Jersey Wharf – Jersey Street Ancoats
Design and Access Addendum
February 2024

PRP architects have been appointed by Manchester Life Development Company 3 limited and John Sisk and Sons Contractor to update the planning application for Jersey Wharf through a Minor Material Amendment (Section 73). The previous planning application reference is 133769/FO/2022 (as amended by 136201/NMC/2023).

The purpose of this Design and Access Addendum is to describe and highlight the proposed changes to the design. This document should be read in conjunction with the planning drawings that are being re-submitted, which are listed at the end of this document.

PROPOSED GROUND FLOOR PLAN

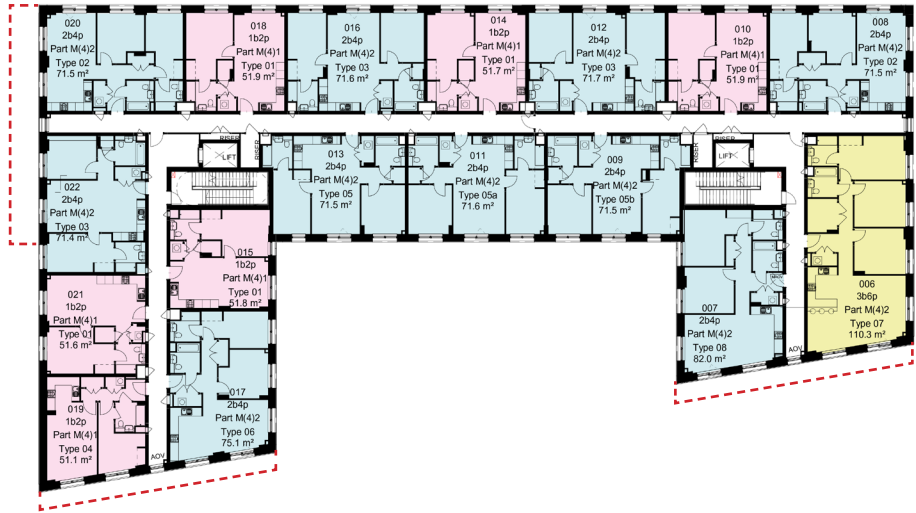
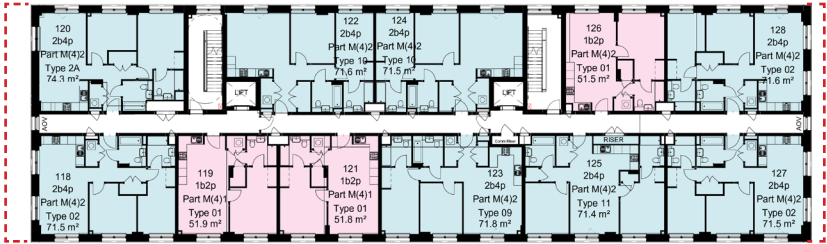
All corner balconies from first to sixth floor have been removed from the scheme. The removal of the balconies has resulted in the building footprint being reduced. The dotted red lines on the floor plan to the right show the previous building footprint, indicating the reduction in overall footprint area.

Minor internal layout changes have also resulted from the change and the total area of commercial space has reduced from 616 sqm to 594 sqm, but the total number of apartments and commercial units remain unchanged. Cycle and refuse storage strategy remain unchanged.

PROPOSED LEVEL 1-6 PLAN

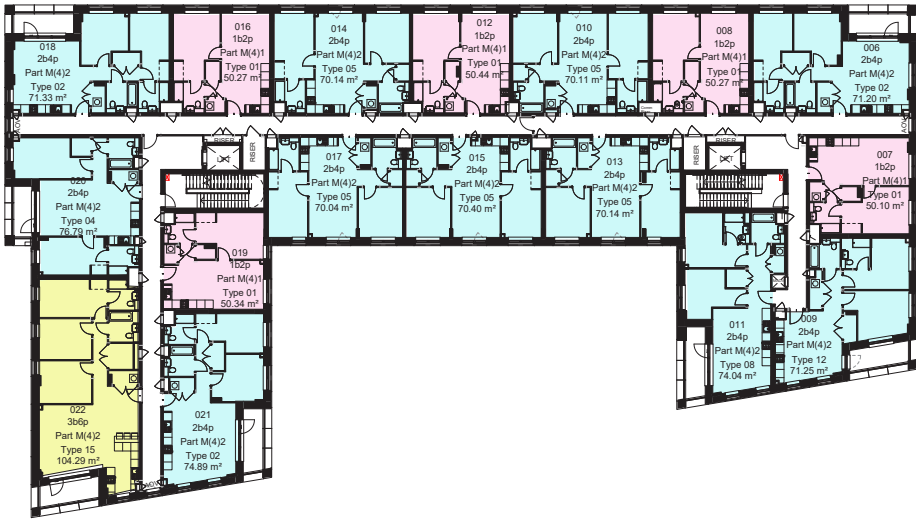
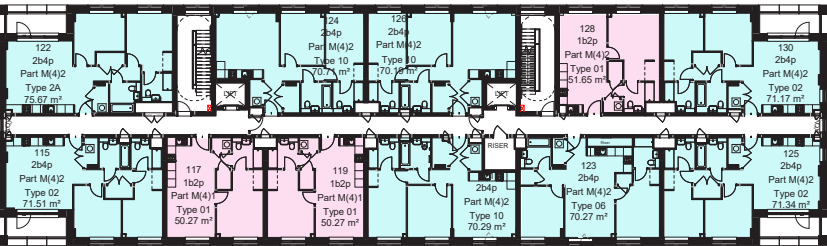
The consented and proposed plans on this page indicate the removal of corner balconies, which has resulted in the reduction of building footprint. The red dotted line indicates the previous building footprint.

There has also be a slight change to the internal apartment layouts and mix change. However all apartments remain compliant with Nationally Described Space Standards (NDSS).

PROPOSED SEVENTH FLOOR PLAN

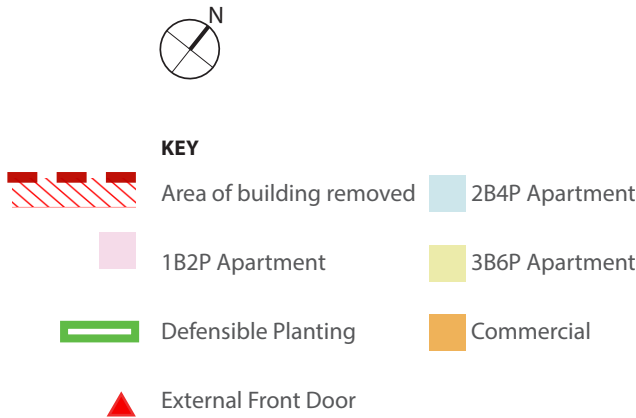
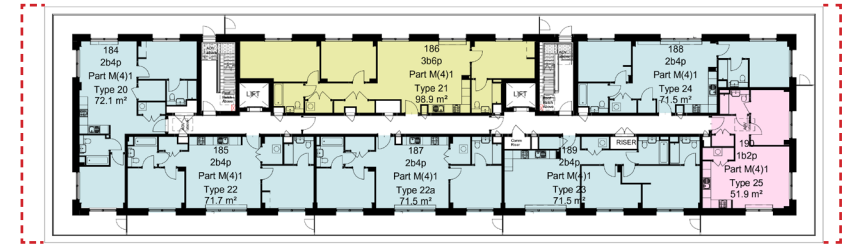
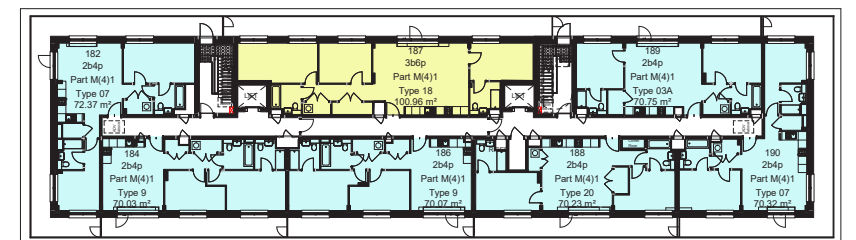
At seventh floor level the external terrace amenity space has been maintained wrapping around the building. The reduction in building footprint has resulted in some changes to internal apartment layouts and mix.

Typical Elevation

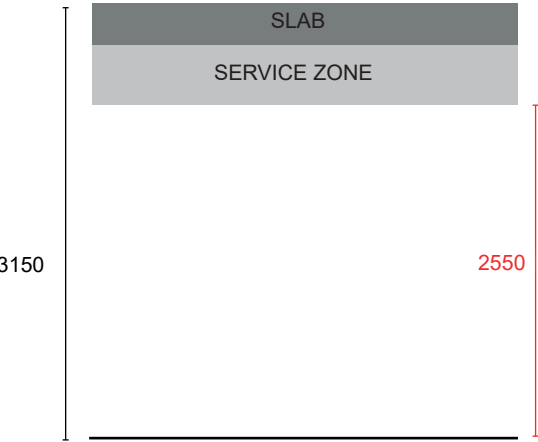
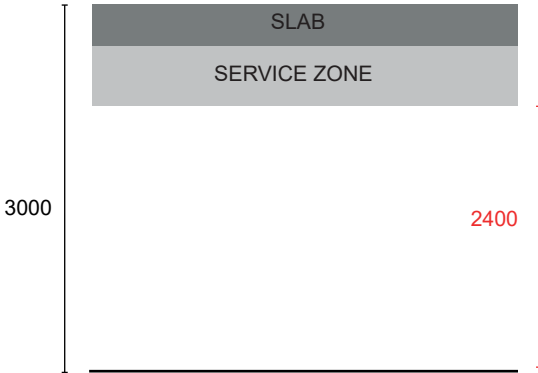
The facade materials are unchanged from the consented scheme. Minor changes to the external facade result from balcony removal on the corners and a reduction in floor to floor height of 150mm from 3150mm to 3000mm on floors one to seven. Ground floor height remains unaltered.

Balconies that have been removed have been replaced with Juliet windows.

The resulting change of reducing the floor to floor heights for floors 1-7 means that the internal floor to ceiling heights and window heights reduce from 2.55m to 2.4m, which is compliant with Nationally Described Space Standards (NDSS). The diagrams on this page and the elevation on the next page illustrates this change.

Proposed Detailed Section & Illustrative Elevation through Commercial Bay and Typical Residential Window

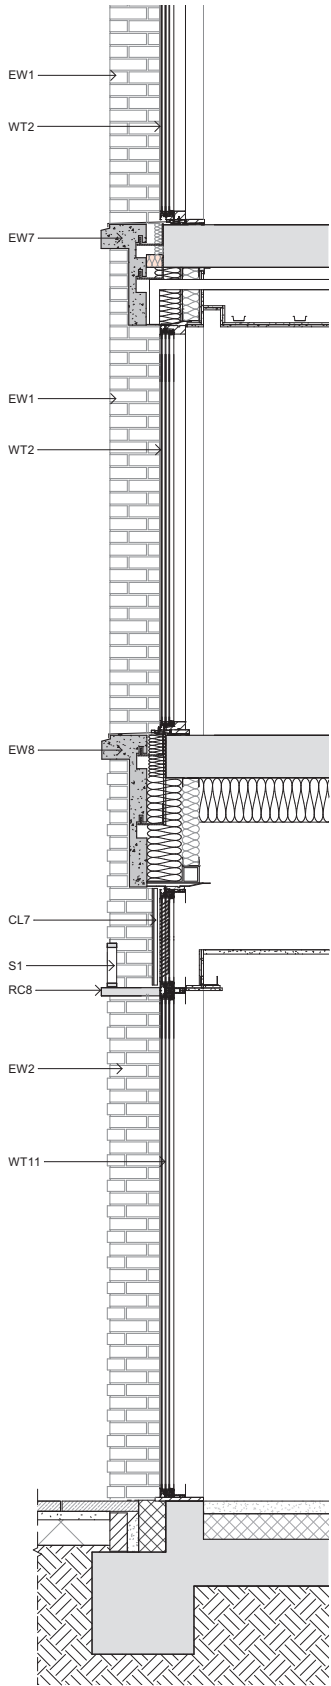
There are no changes to this detailed elevation other than the floor to floor heights reducing from 315m to 3m on levels 1-7.

Proposed Detailed Section & Illustrative Elevation through Main Entrance

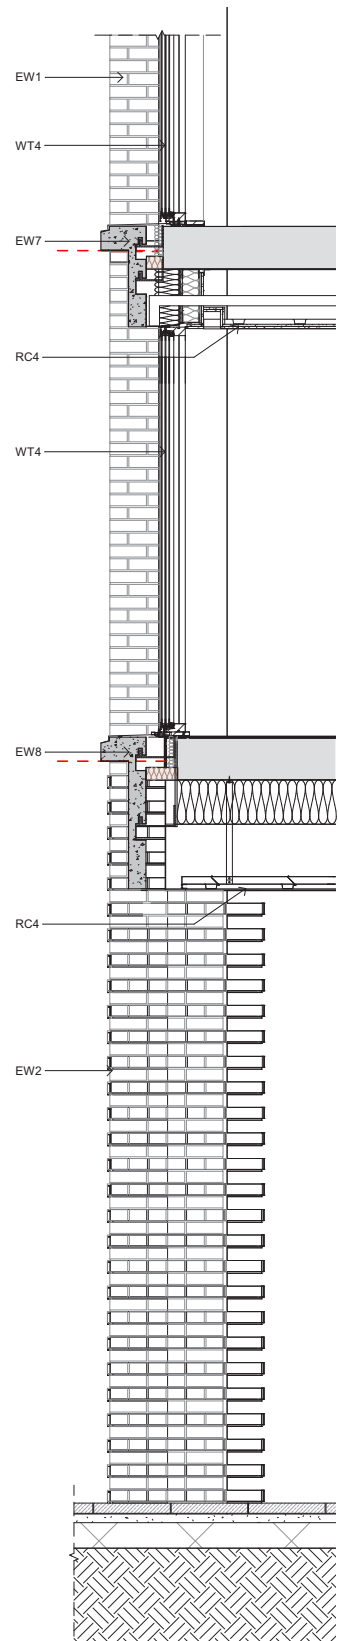
Changes to the detailed elevation have resulted from the removal of the balconies above the entrance. Wlist the balconies have been removed above a recessed and covered entrance has been maintained.

Proposed Detailed Section & Illustrative Elevation through Refuse Store and Typical Residential Window

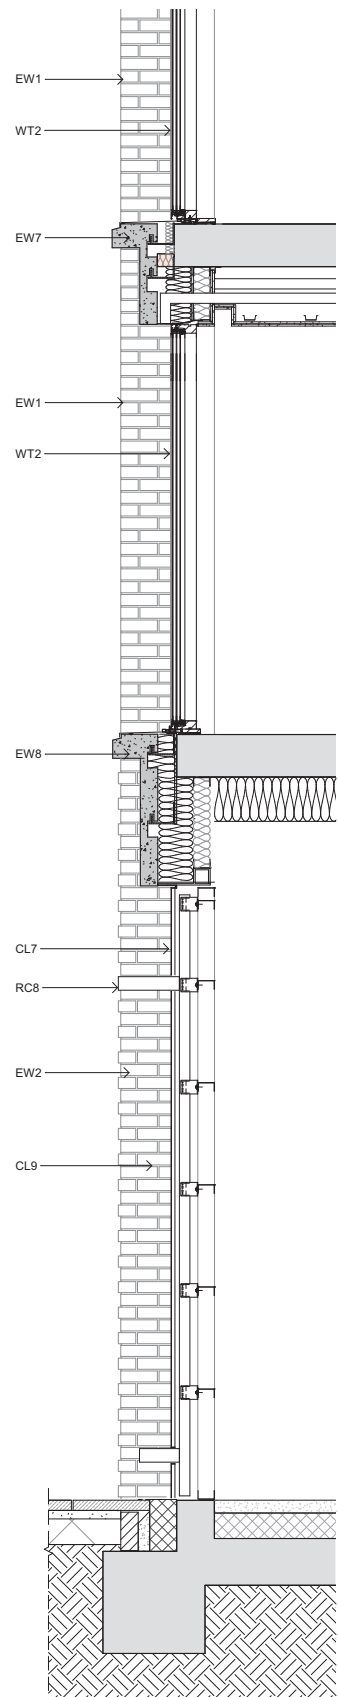
There are no changes to this detailed elevation other than the floor to floor heights reducing from 315m to 3m on levels 1-7.

Proposed Detailed Section & Illustrative Elevation through Seventh Floor Terrace

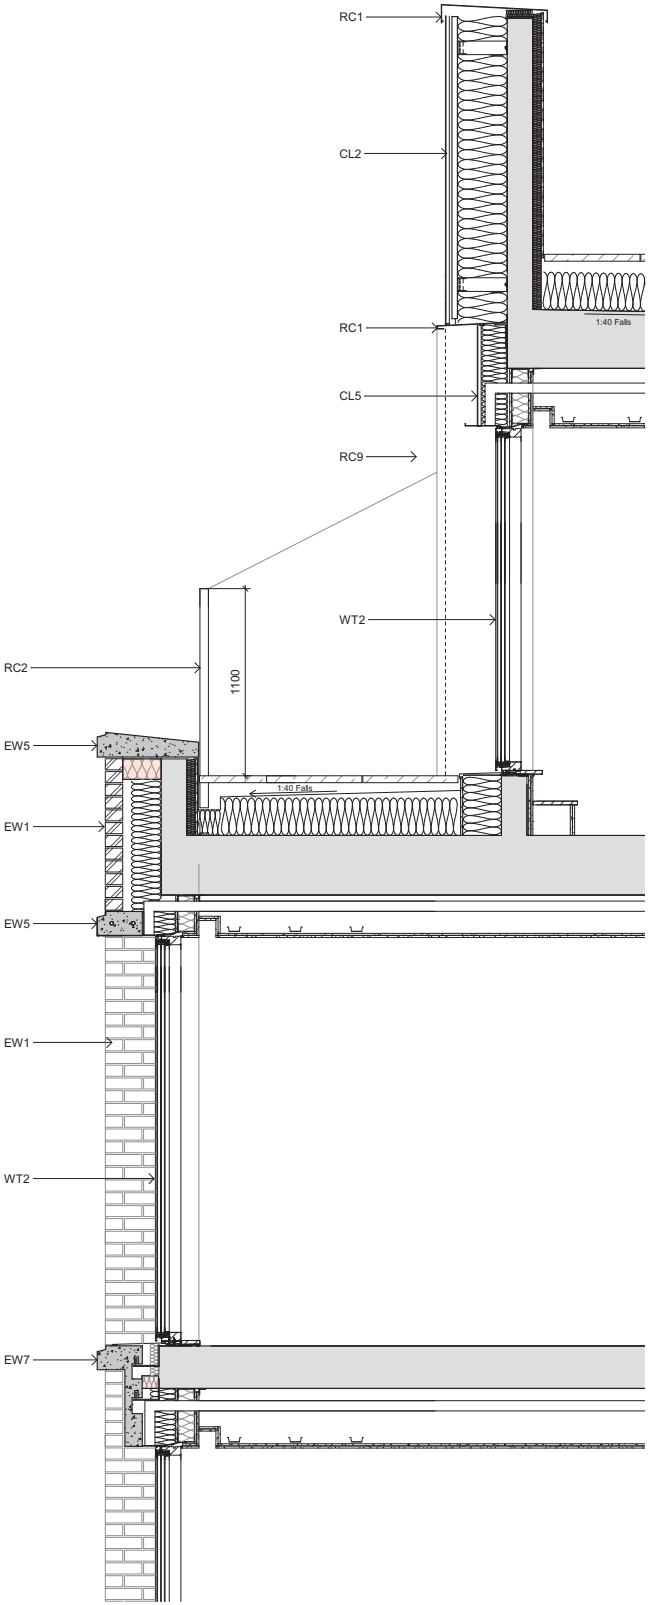
There are no changes to this detailed elevation other than the floor to floor heights reducing from 315m to 3m on levels 1-7.

Public Realm

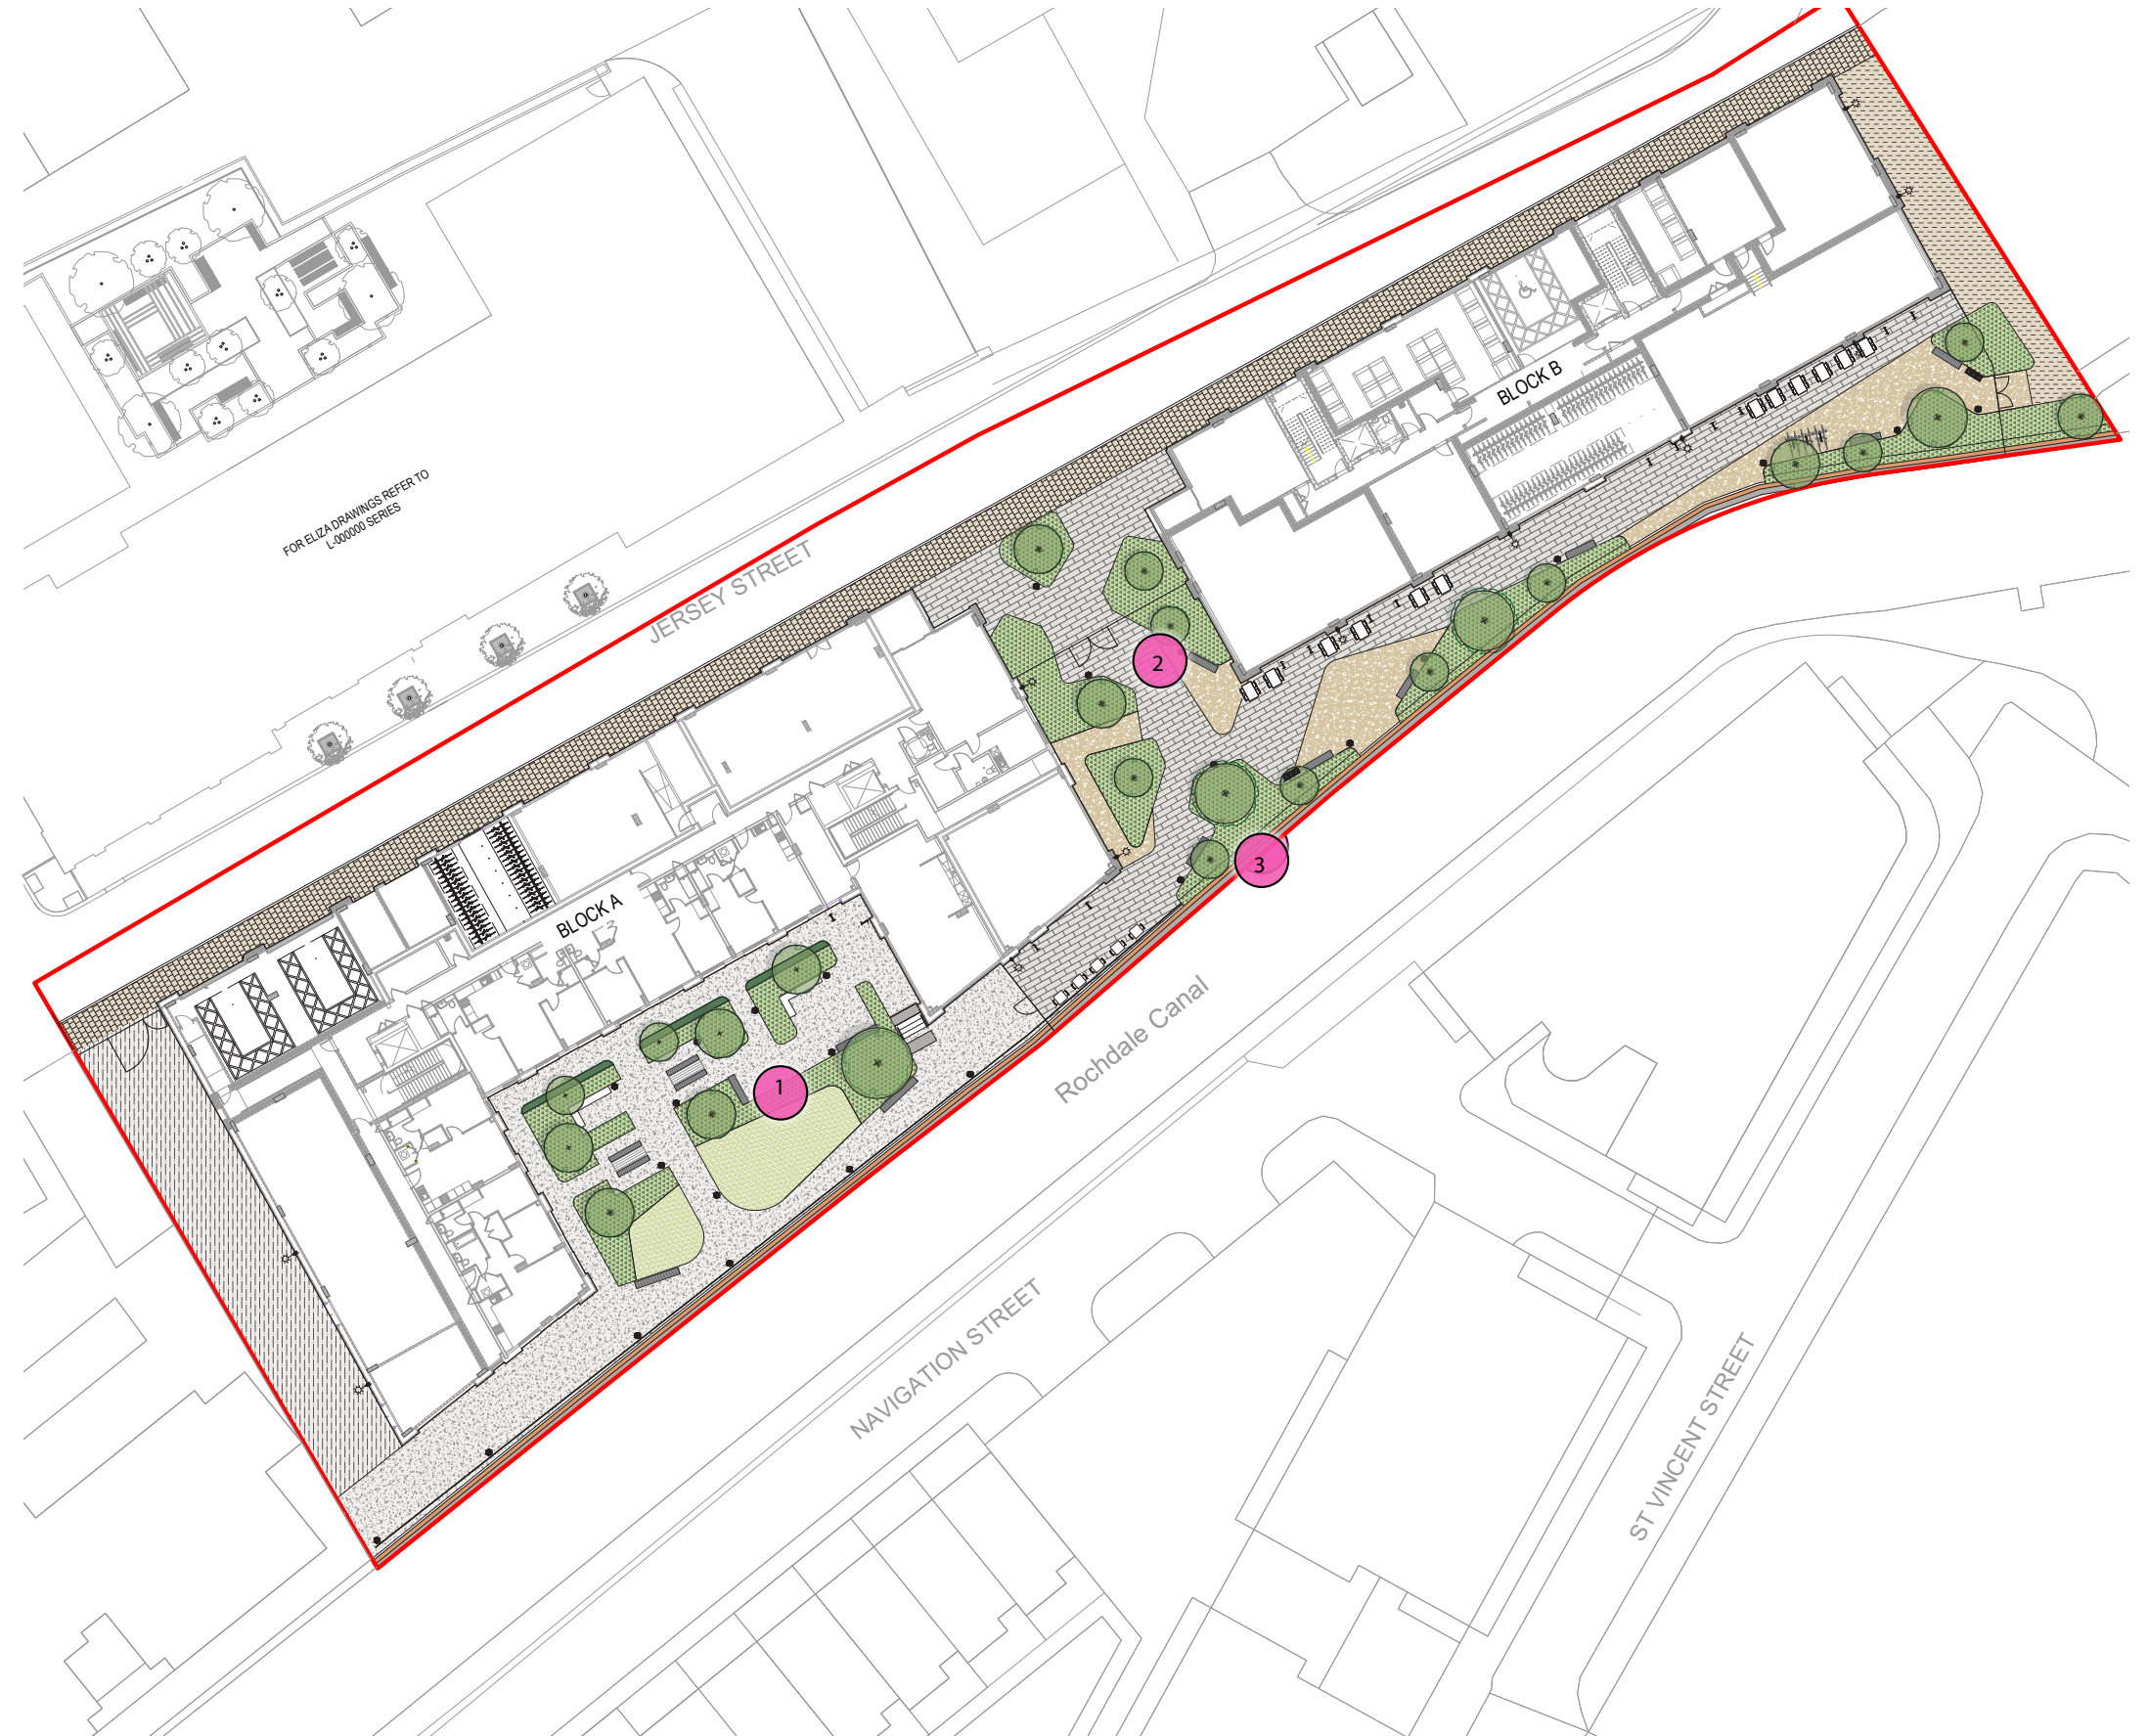
The private courtyard has been updated to provide a self-binding gravel surface instead of a resinbound gravel material. This will maintain permeability and reduce embodied carbon of the landscape design

Inclusion of fencing and gates

This will provide security at night for the canal-side spaces but be open during the day for public access

Buff coloured resinbound gravel areas define and break up the space within the publicly accessible area. This will help create character and definition for the adjacent commercial units.
